CITY OF SUN VALLEY
PLANNING AND ZONING COMMISSION
AGENDA REPORT

Agenda Item: **Geneva Equities Single Family Residence Design Review Application No. DR 2014-34**

SUBJECT: Site visit and public hearing for a design review application proposing the construction of a new 4,543 gross square foot, two-story single family dwelling with attached garage and associated site improvements on an existing vacant lot in the Single-Family Residential (RS-1) Zoning District. **Applicant:** David Hertel, AIA, LLC for Geneva Equities, LLC. **Application Filing Date:** October 14, 2014. **Location:** Lot 18 Fairway Subdivision; 403 Fairway Loop.

Date: 10/24/2014
To: Mark Hofman
Re: 2014-34/ Geneva Equities Residence/ 403 Fairway Loop

SHEET TITLE
SITE / CONSTRUCTION & MANAGEMENT PLAN

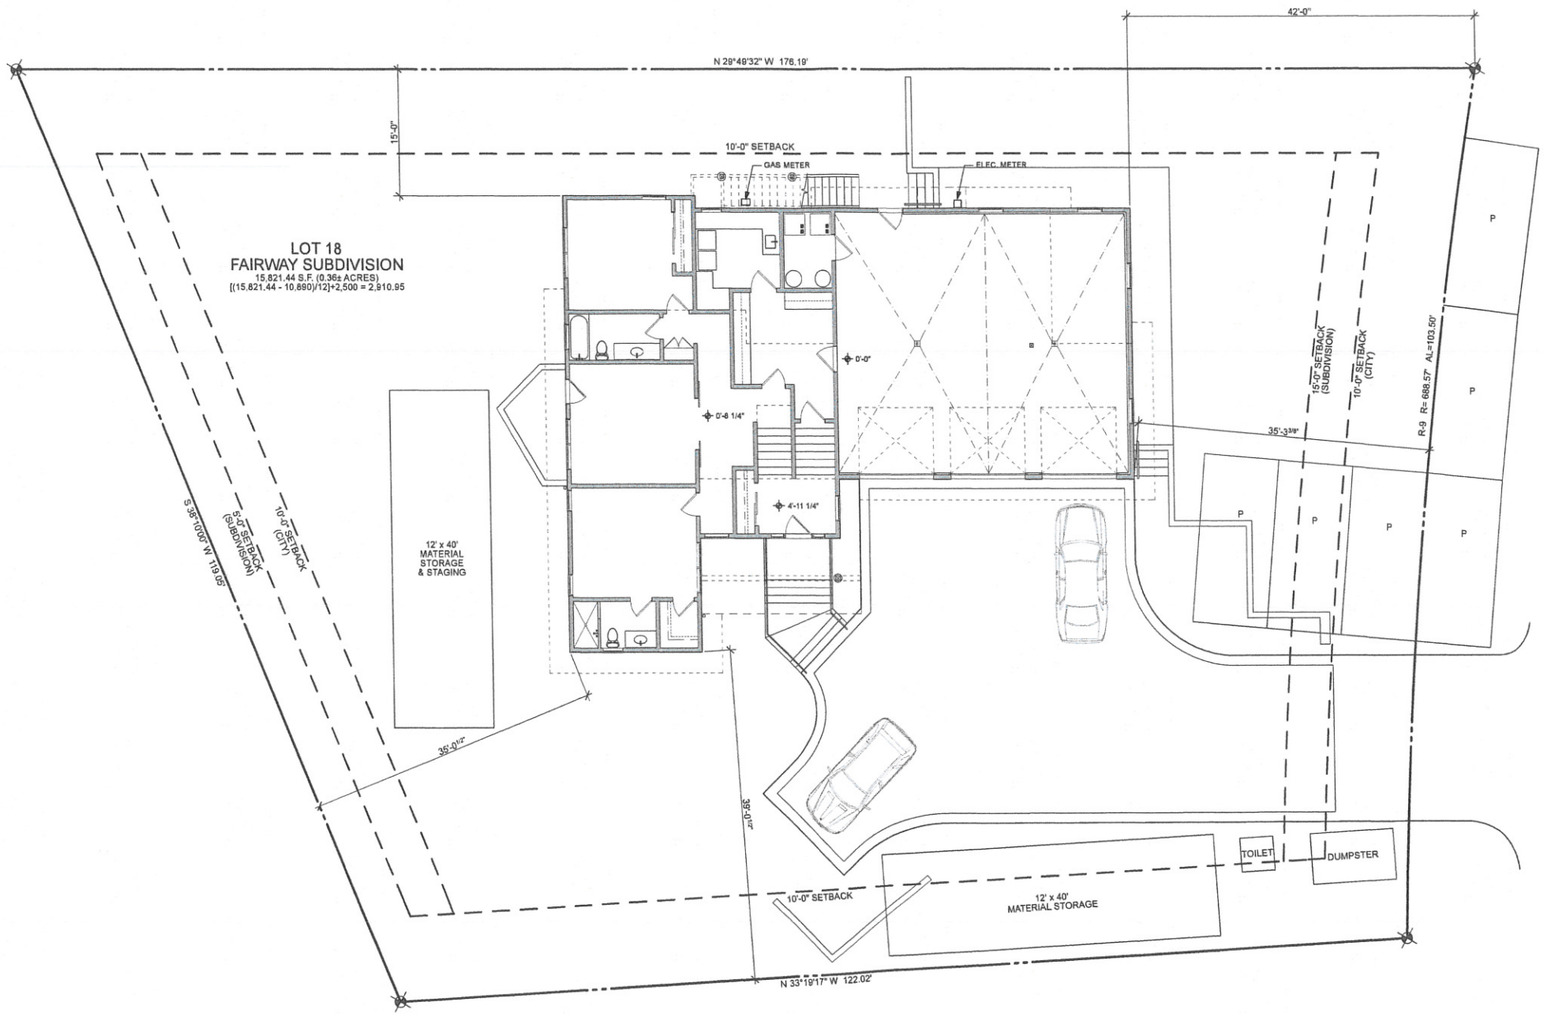
1. The drive way shown on the plans indicates a width of 16 feet.
   The driveway shall have a minimum width of 20 feet to accommodate fire department access and to meet the required hose reach to extend within 150 feet to all portions of the exterior walls of the first story of the residence.

1 MAIN LEVEL FLOOR PLAN
SCALE: 1/8" = 1'-0"

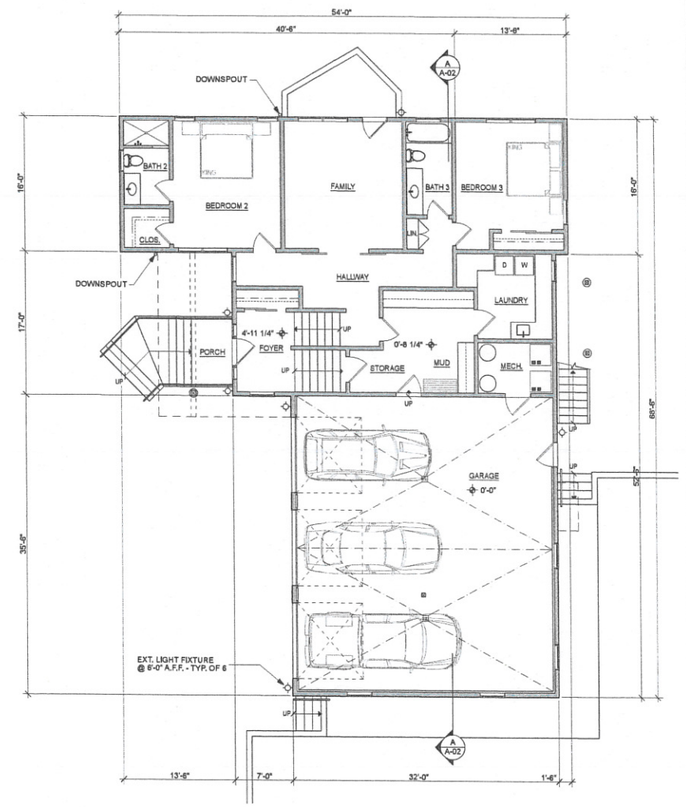
1. Exterior landing at garage man door is not the required 36" in length.
2. A hand rail is required on exterior stairs across from the garage man door.
3. No other apparent discrepancies.
